## GAS FLOW CHART REVISION

SRXB has reviewed Figure 4. Several items were immediately identified as warranting discussion during a public meeting:

Figure 1 Historic flow chart that addresses vortexing

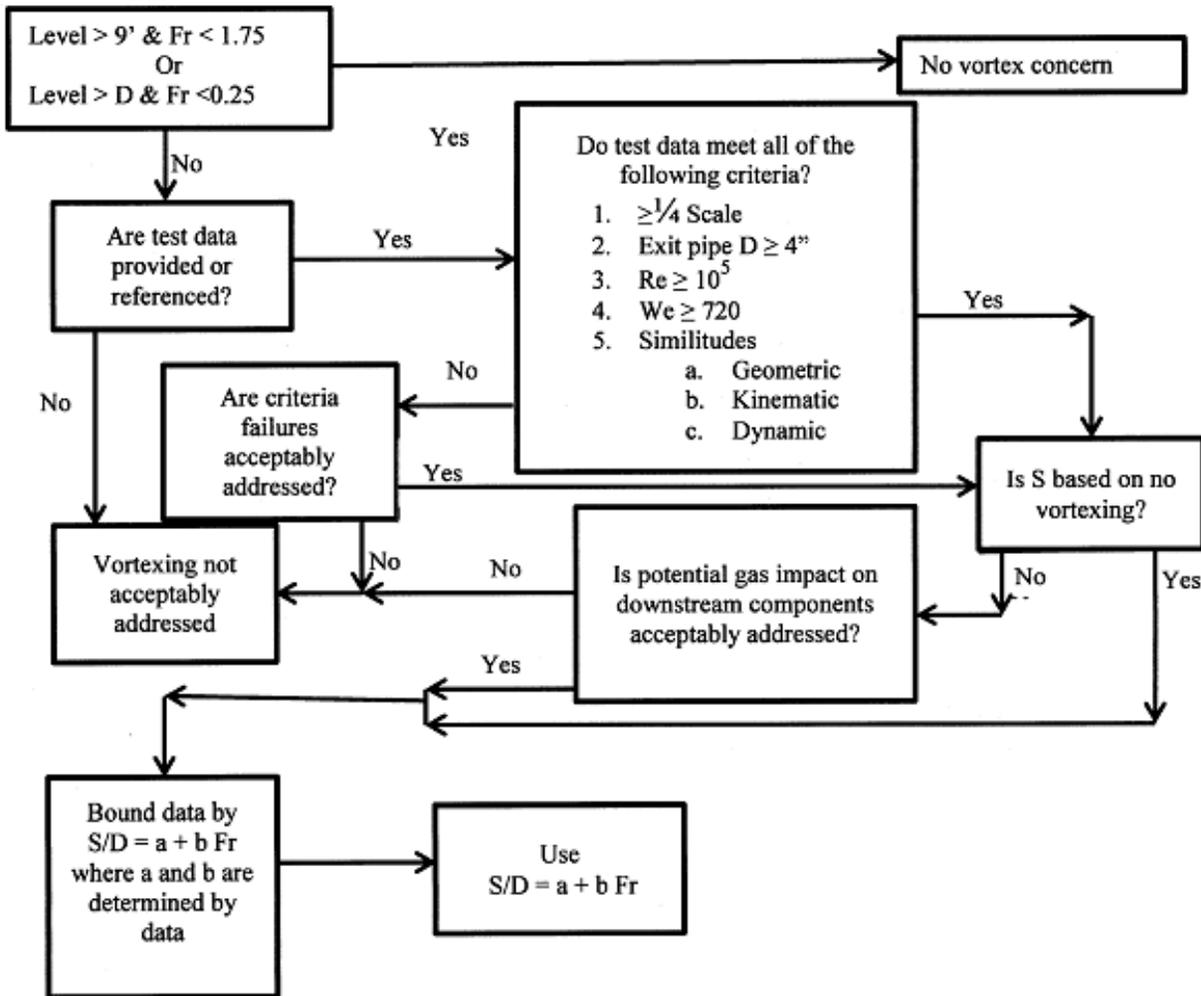
Limiting the phenomena to vortexing misses the important characteristic of localized level depression. Under some circumstances a localized level depression will form in the vicinity of an exit pipe without a surface swirl that would be characteristic of a vortex. Figure 2 illustrates two possibilities.

Figure 1 was not limited to draining from tanks but was also applicable to residual heat removal (RHR) midloop operation when taking suction from pressurized water reactor (PWR) hot legs. The Nuclear Regulatory Commission (NRC) Reactor Systems Branch (SRXB) position is considering whether a revised flow chart could be applicable to such conditions and configurations.

Figure 4 Suggested Modified Flow Chart

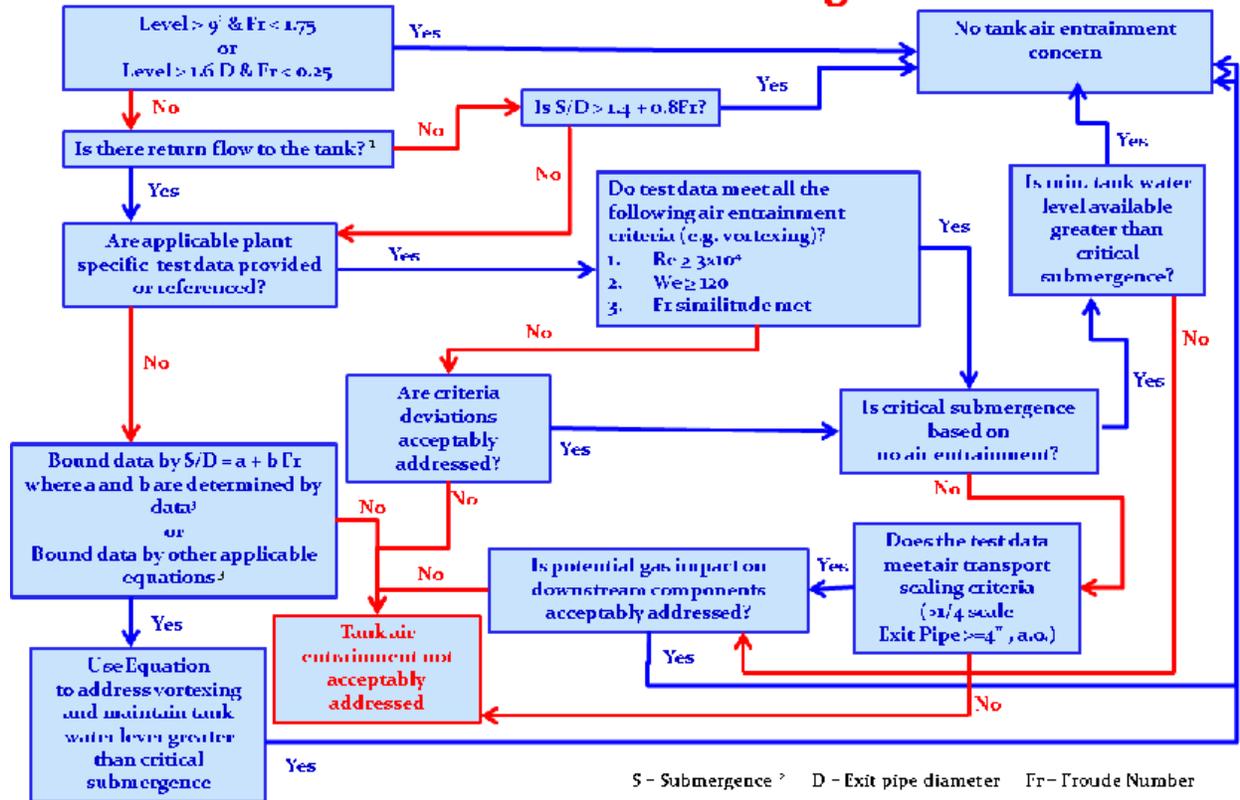
1. The focus is on vortexing and drawing water from a tank. A broader scope is needed that addresses other phenomena and other water sources.
2. The test using  $S/D = 1.4 + 0.8 Fr$  is not useful since S is not known. (S = critical water level, the level where gas ingestion becomes a concern; D = exit pipe inside diameter). If “water level” is substituted for “S,” this becomes a useful improvement.
3. If applicable plant data are not provided or referenced, then apparently, any data can be used to eliminate a gas concern. Acceptable data should be limited to data that meet specified criteria.

SRXB has drafted the Figure 5 chart for discussion during the public meeting.

Figure 5 Revised flow chart

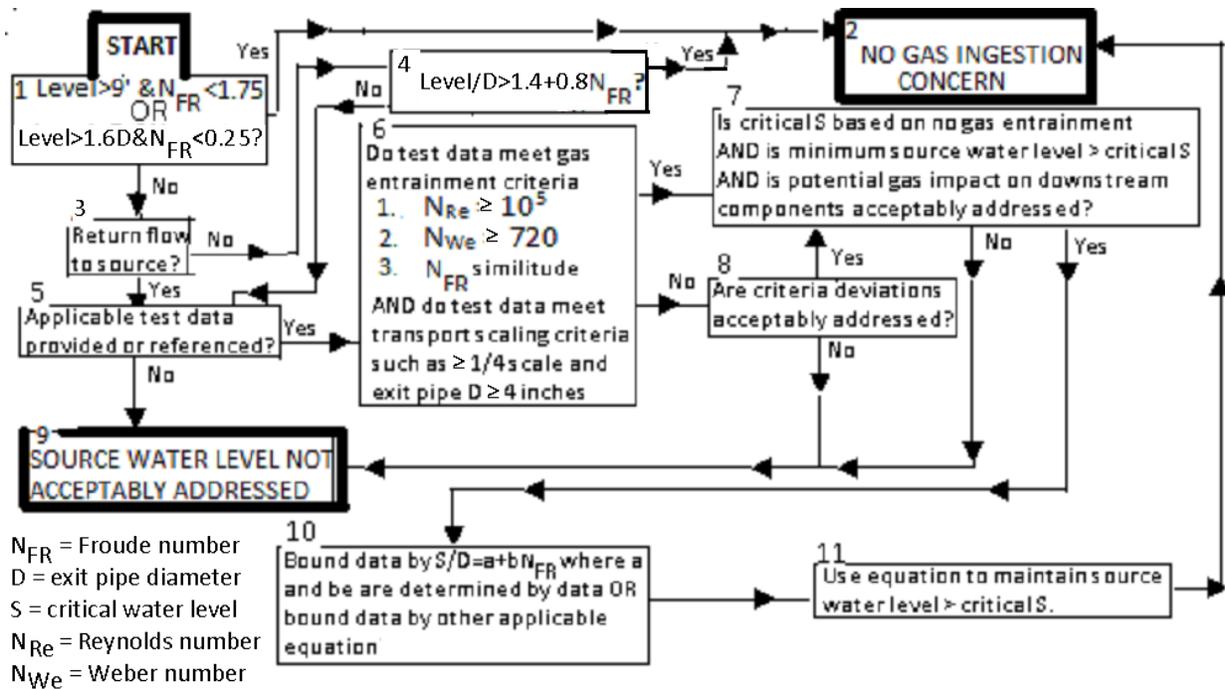
The Figure 1 chart focused on vortexing as part of a planned NUREG. The NRC is no longer considering preparation of a NUREG but rather is considering development of a Regulatory Guide that addresses gas ingestion topics. The scope will include both draining from tanks and from other water sources such as RHR operation using PWR hot legs as the water source. Phenomena will not be limited to vortexing but will include such topics as localized reduced water level. The SRXB draft flow chart reflects these considerations.

Each step in the SRXB chart is numbered. Information regarding these steps is as follows:

Figure 7. Alden Test Results

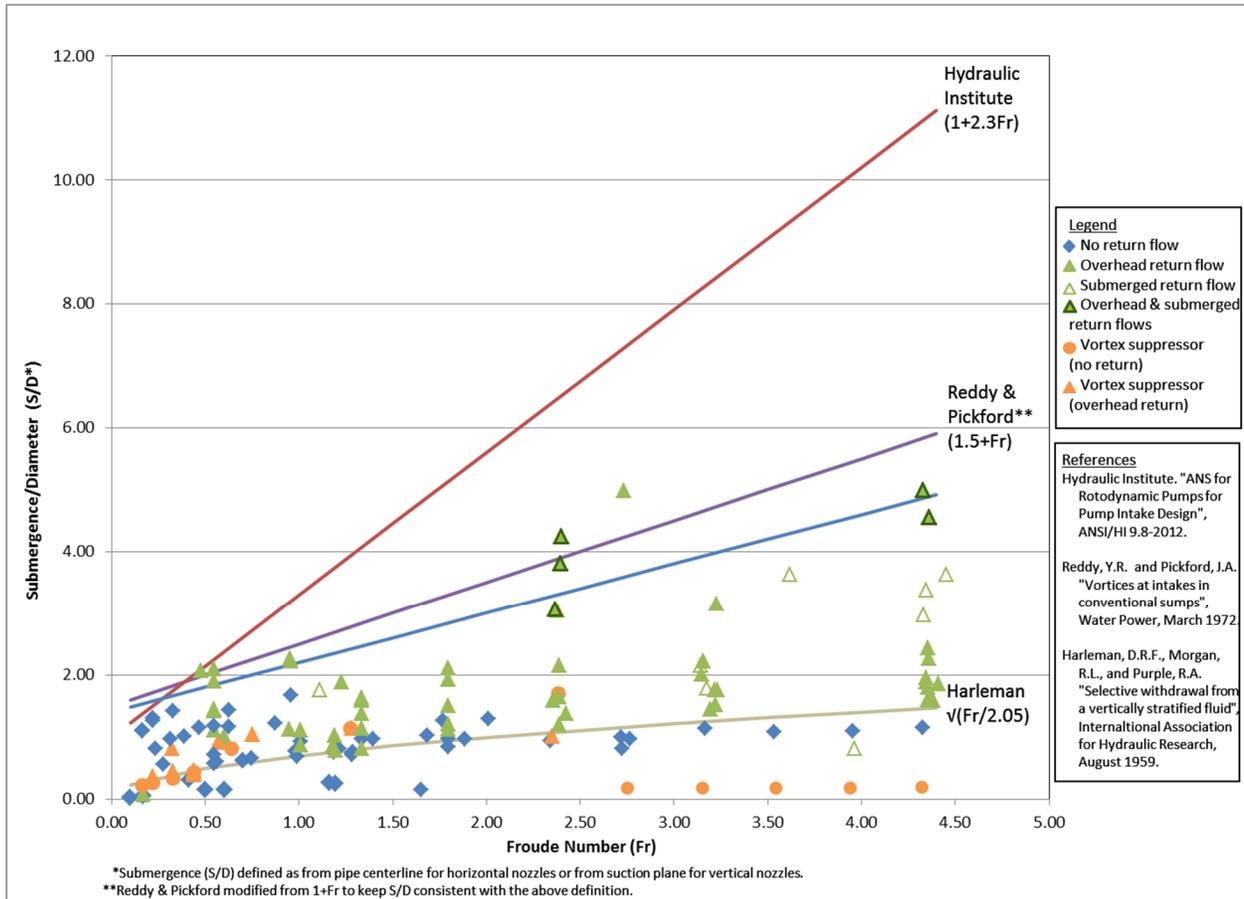
- All suction flow only data without return flow are below  $S/D = 2$ .
- Caution is necessary when drawing a conclusion for  $N_{FR} > 2$  as all data come from one configuration.
- In general, it is not possible to state whether return flow will increase or decrease required submergence. This depends on return angle, return height, and its location relative to the outlet.
- The Froude similitude model does not fully model all of the characteristics of overhead return flow. Bubble behavior and impact may be issues.
- Bubble size and rise velocity are scalable but are prototypic. Therefore, initiation and the extent of air bubble withdrawal into the suction nozzle from jet impingement is not conservative.

- Bubble size and therefore rise velocity does not scale.
- The data are not conservative since the basis was observation of air ingestion or a Type 6 vortex. Users of the ARL data should address the potential for some gas to have been ingested and should address the implications accordingly. An estimate of the time in which gas could have been ingested is acceptable as part of this assessment.

The unlabeled blue line is described by  $S/D = 1.4 + 0.8 N_{FR}$  which describes the data obtained when there is return flow to a simulated refueling water storage tank (RWST). This line generally bounds the data by a substantial margin where there is no return flow. Therefore, if level is greater than this line with no return flow, it is acceptable to assume little gas ingestion and **Item 2** is entered.
